# REPORT OF THE MIAMI-DADE COUNTY WELLFIELD TECHNICAL WORKGROUP

Prepared for Miami-Dade County

August 2017

**Wellfield Technical Work Group  
Final Report  
July 2017**

**Figure ES-1**  
Comparison of Travel-Time Distances to Rock-Mining Areas

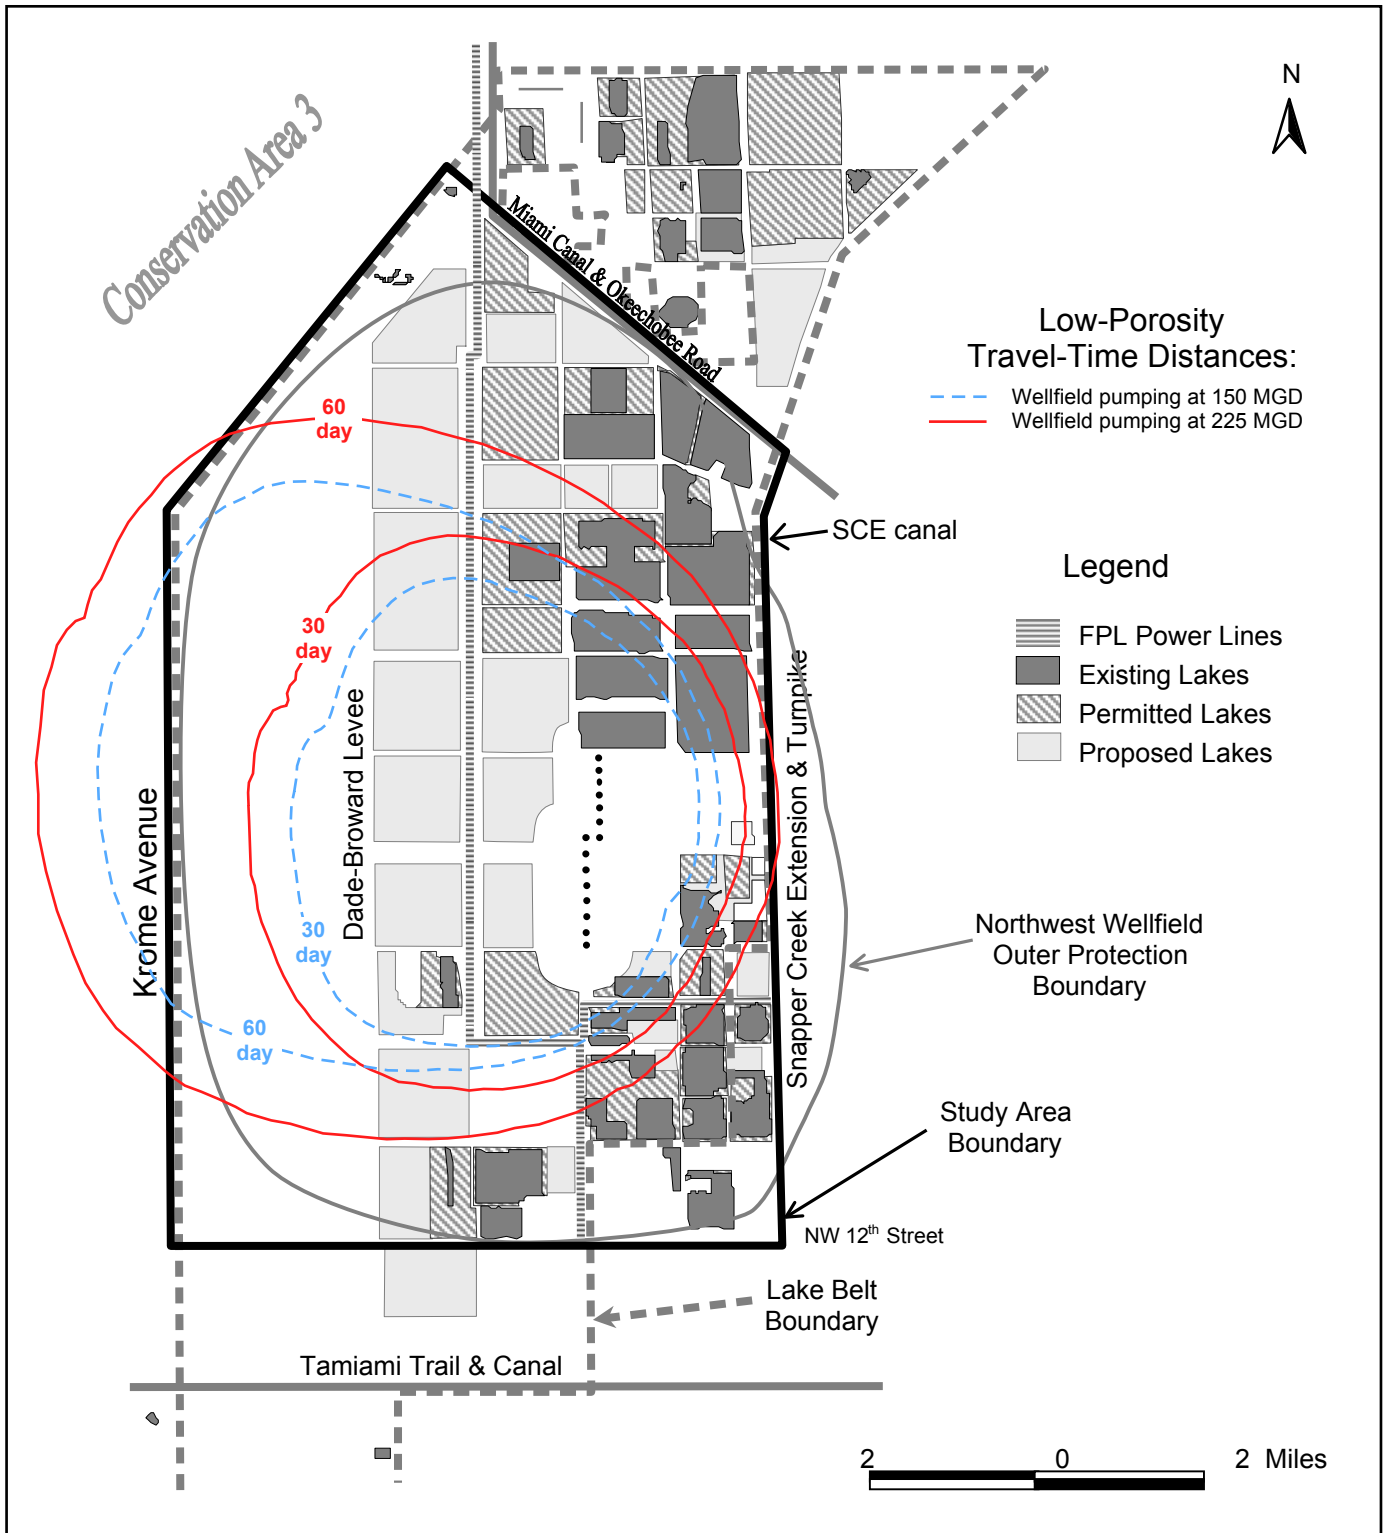
and most of the proposed rock-mining areas are within distances with less than 30-day and 60-day travel times to the wellfield (see Figure 5)<sup>6</sup> even under the current pumping rates; mining operations in these areas should be prohibited or restricted under the terms of the current regulations.

**Major Error #1a: 30-day travel time contours**

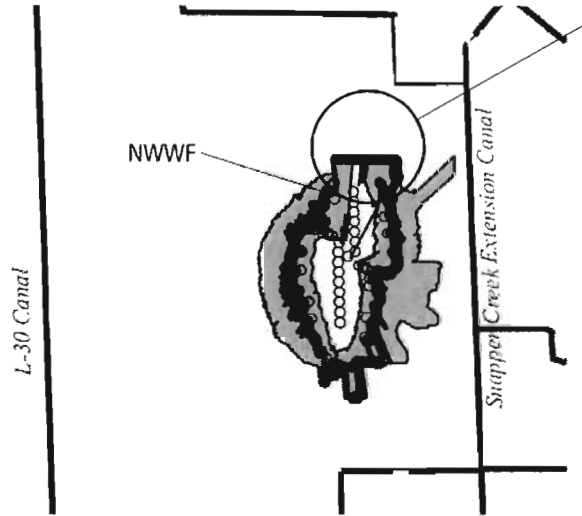
USGS model: ~83 days to travel through Lake 11

Reality: ~4 days to travel through Lake 11

**Major Error #1b: 210-day travel time contours**

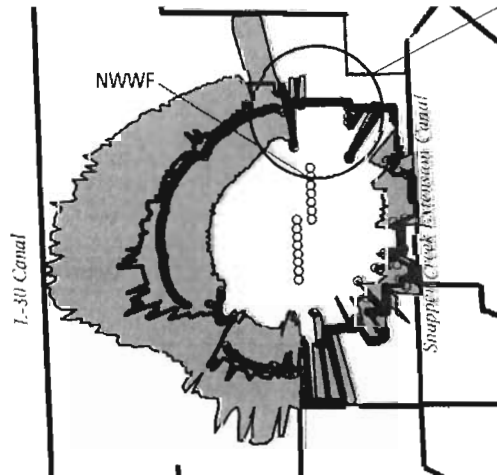
USGS model: More than 210 days to travel through 2 lakes

Reality: Probably ~10-15 days to travel through 2 lakes

**Major Error #3: Inconsistent application of well-mixed reservoir theory**

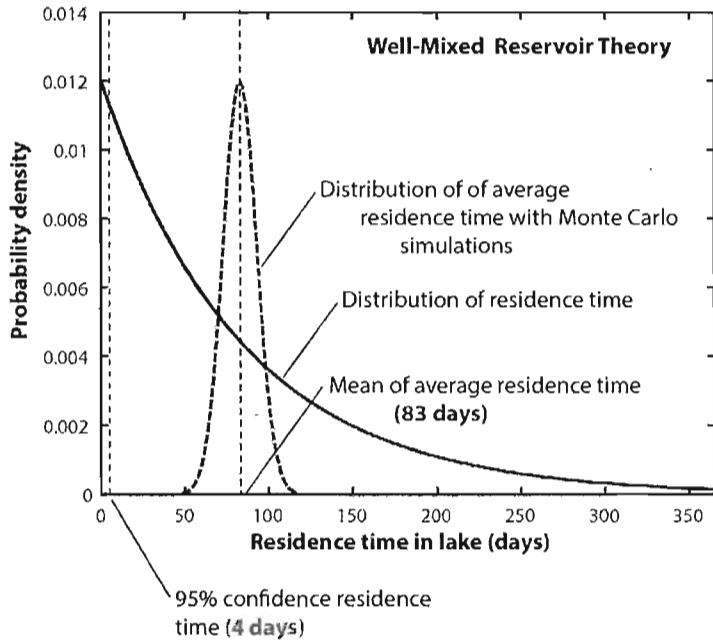
(Monte Carlo simulations only vary the average residence time in the lake.)

This is inconsistent with the calculation of travel-time contours with 95% confidence.

**Concern #1: Inappropriate Location of Confidence Interval:**

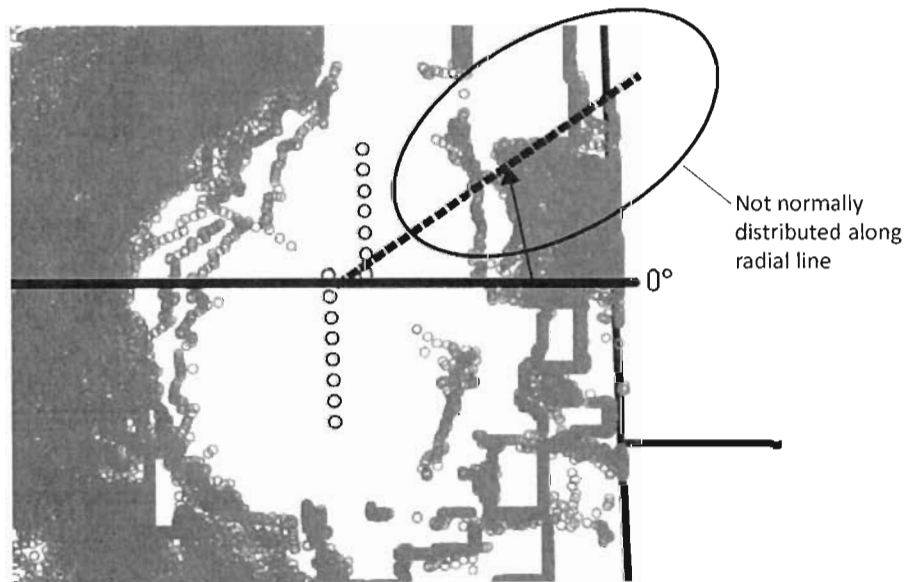
[Varljen and Schafer (1991) method not appropriate]

**Concern #2: Ragged Confidence**

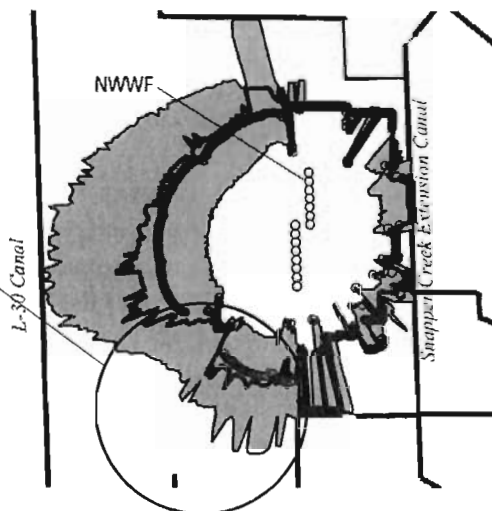
Unrealistic, due to insufficient number of particles
